**ADDENDUM NO. 2**

**PROJECT NAME:** East Stadium Bid Package 5  
**UNL PROJECT NUMBER:** C049P136

DATE OF ISSUANCE: January 9, 2012  
DATE OF BID OPENING: January 11, 2012

**10** SECTION DETAIL @ SOUTH VESTIBULE CURB  
 SCALE: 3/4" = 1'-0"

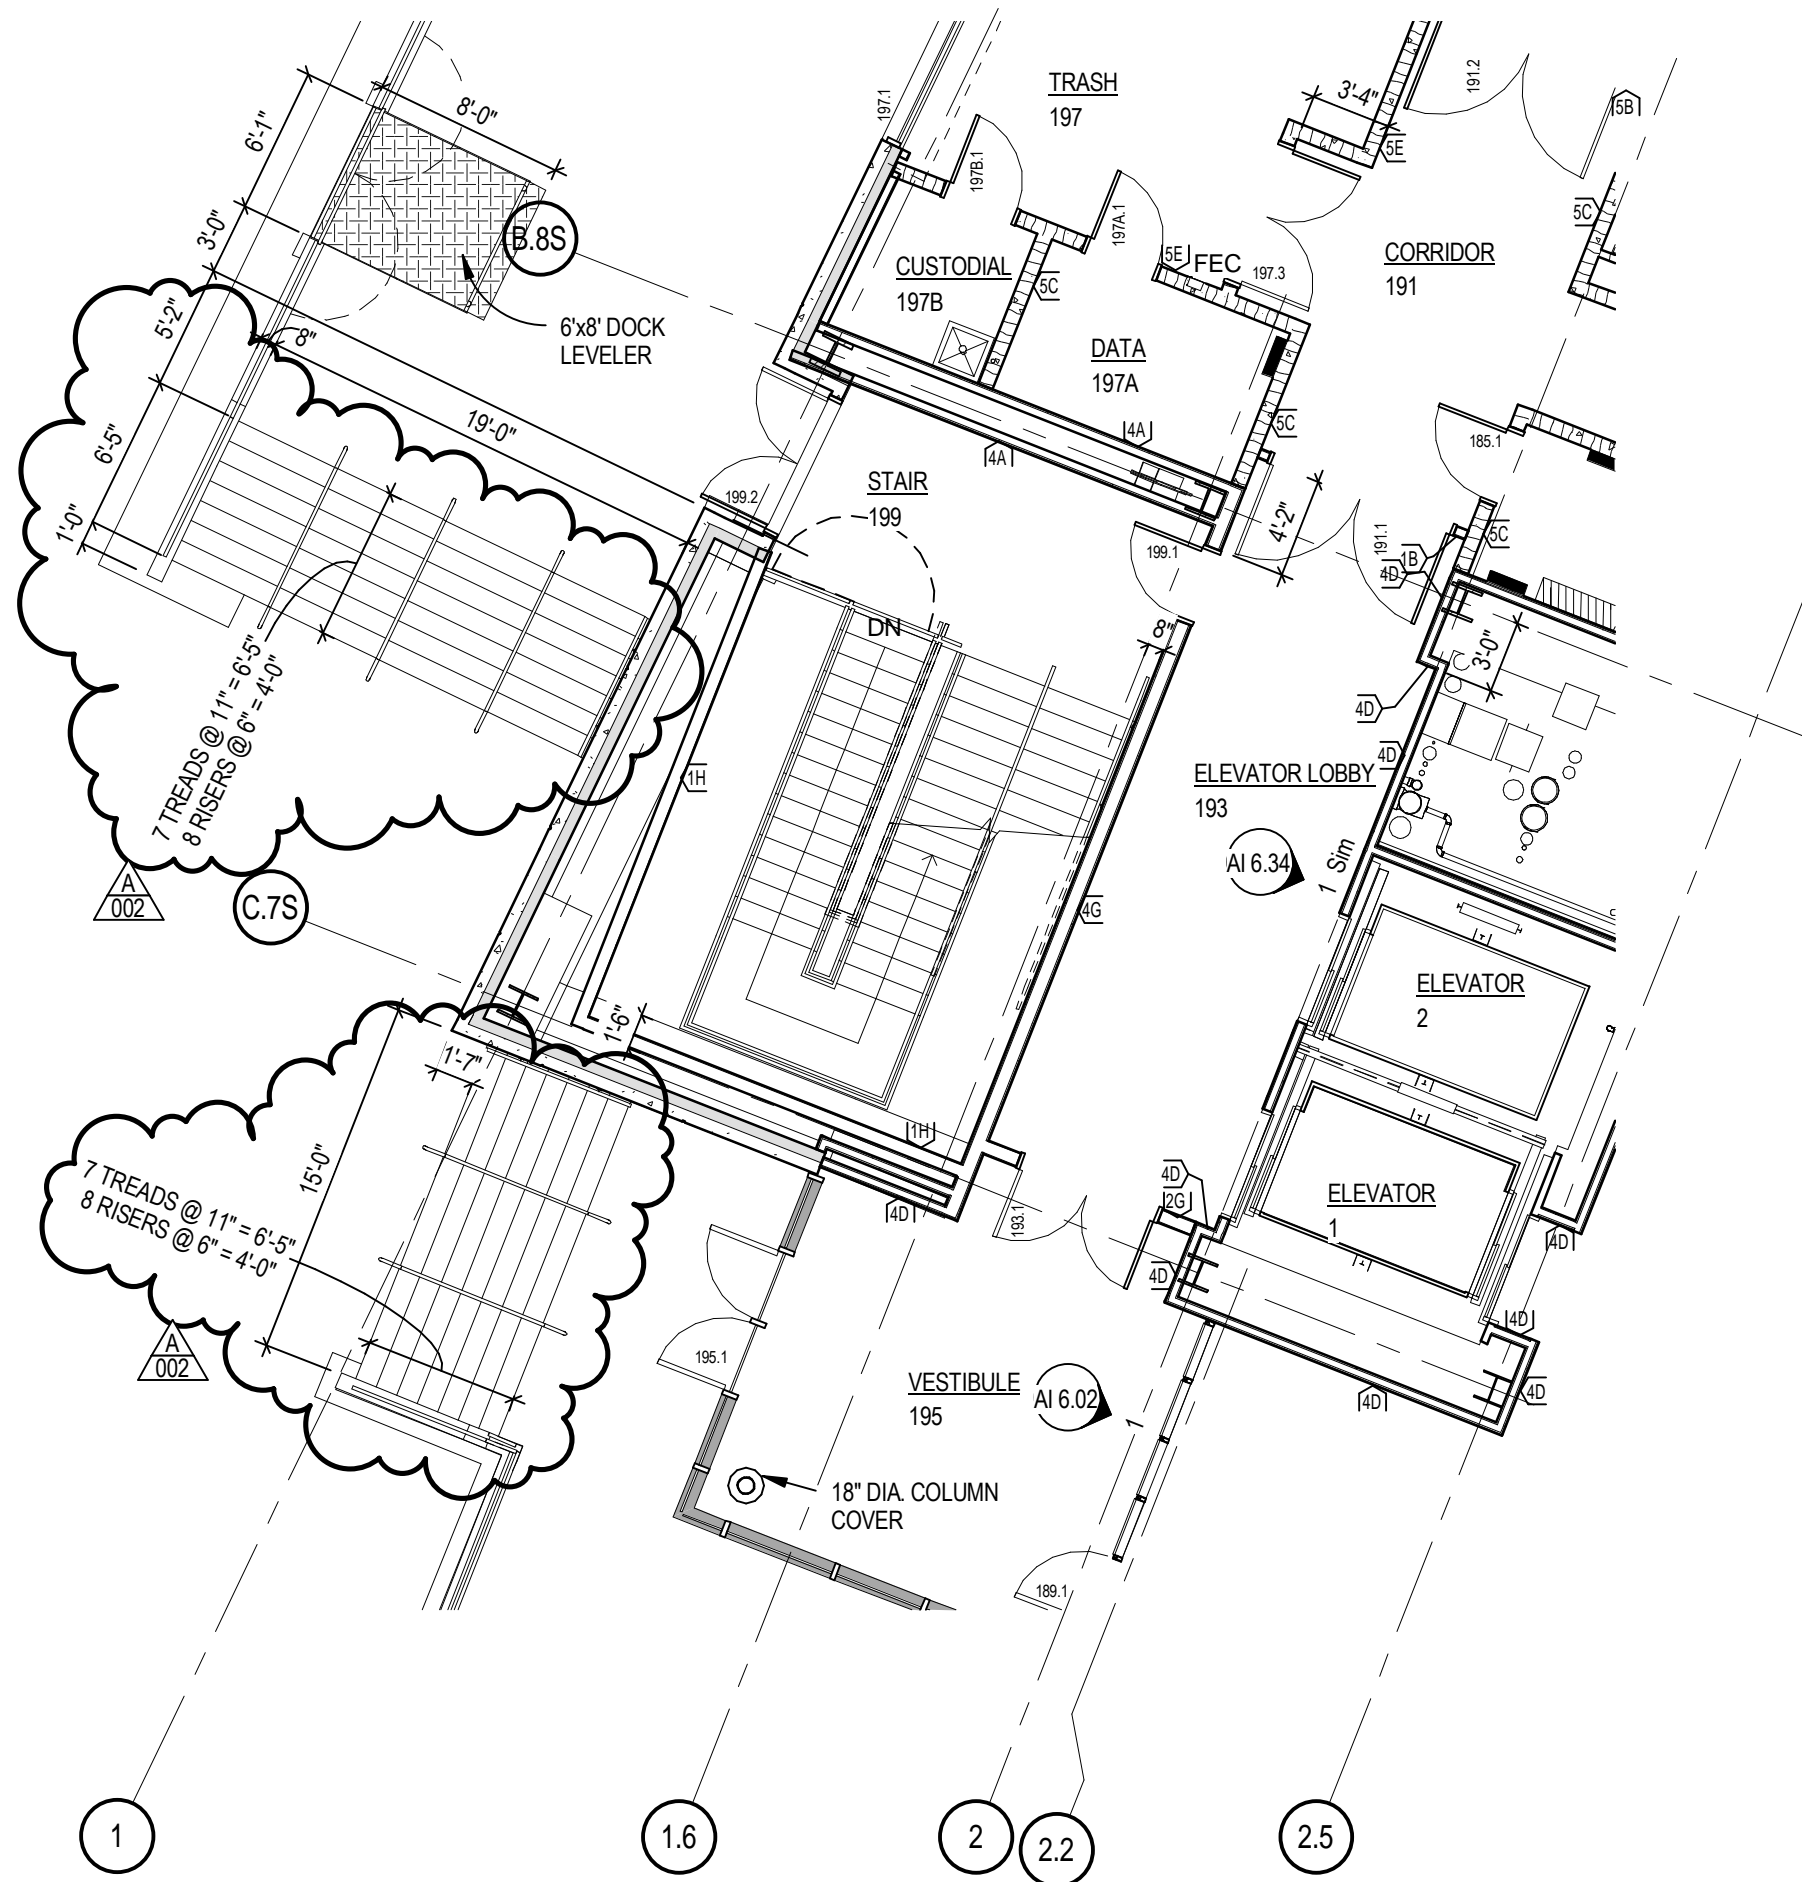
- a. Detail 9AE6.24 – CLARIFICATIONS – Refer to attached Architectural Supplemental Drawing, SDAE-5 for further detail and clarifications to this detail.
- b. Detail 10AE6.24 – CLARIFICATIONS – Refer to attached Architectural Supplemental Drawing, SDAE-6 for further detail and clarifications to this detail.
